Morecambe Offshore Windfarm: Generation Assets Examination Documents

Marine Mammal Technical Note 1 (EIA) (Tracked)

Document Reference: 9.25.1

Rev 024

Figure 2.1 Ambient underwater noise following Wenz (1962) showing frequency dependency from different noise sources

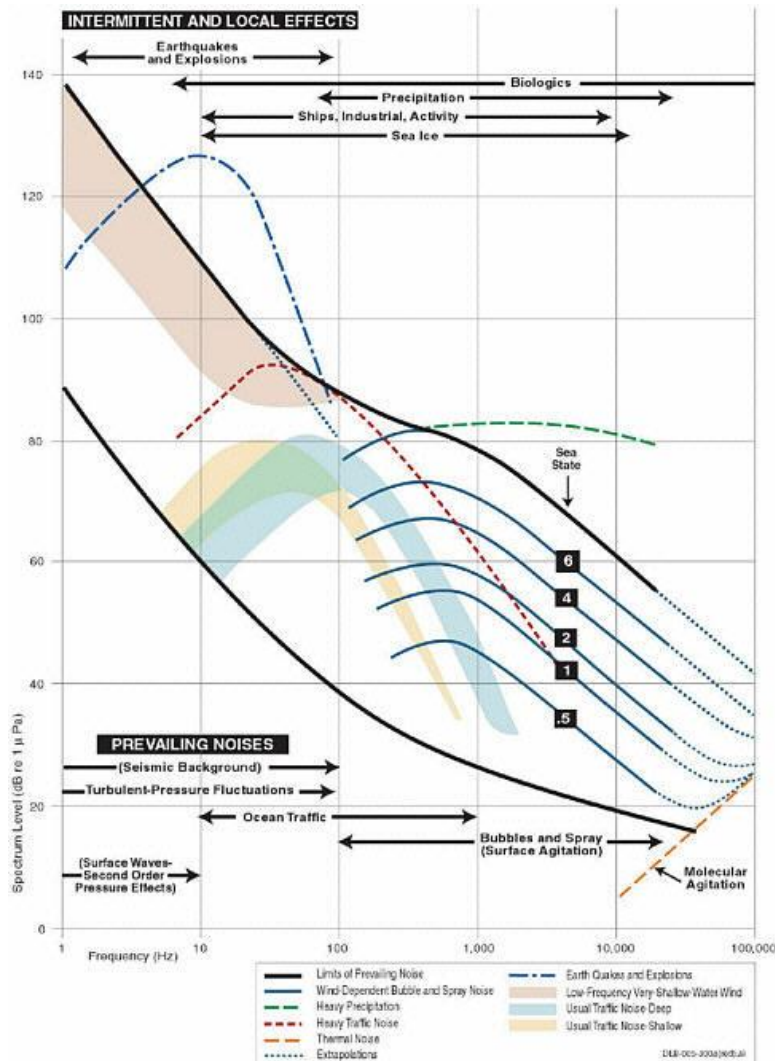
4. The following information is provided in response to NE's comment (NE Ref D16, RR-061-180):

9. Typical underwater noise levels show a frequency dependency in relation to different noise sources; the classic curves are given in Wenz (1962) and are reproduced in **Figure 2.1** below. **Figure 2.1** shows that any unweighted overall (i.e., single-figure non-frequency-dependent) noise level is typically dependent on the very low frequency element of the noise. The introduction of a nearby anthropogenic noise source (such as piling or sources involving engines) will tend to increase the noise levels in the 100 Hz to 1 kHz region, but to a lesser extent will also extend into higher and lower frequencies.

15. In response to NE's comment on baseline noise levels (NE Ref D16, RR-061-180), the Applicant has undertaken a review of available evidence and data sources, including data collected for historic OWF in the Irish Sea, to meet the requirement of NPS EN-3 paragraph 2.8.131. The Applicant considers that the information presented is sufficient to demonstrate that the level of background noise is below the threshold at which it would influence the assessments, and therefore that the information in Appendix 11.1 Underwater Noise Assessment (APP-065) is unchanged.
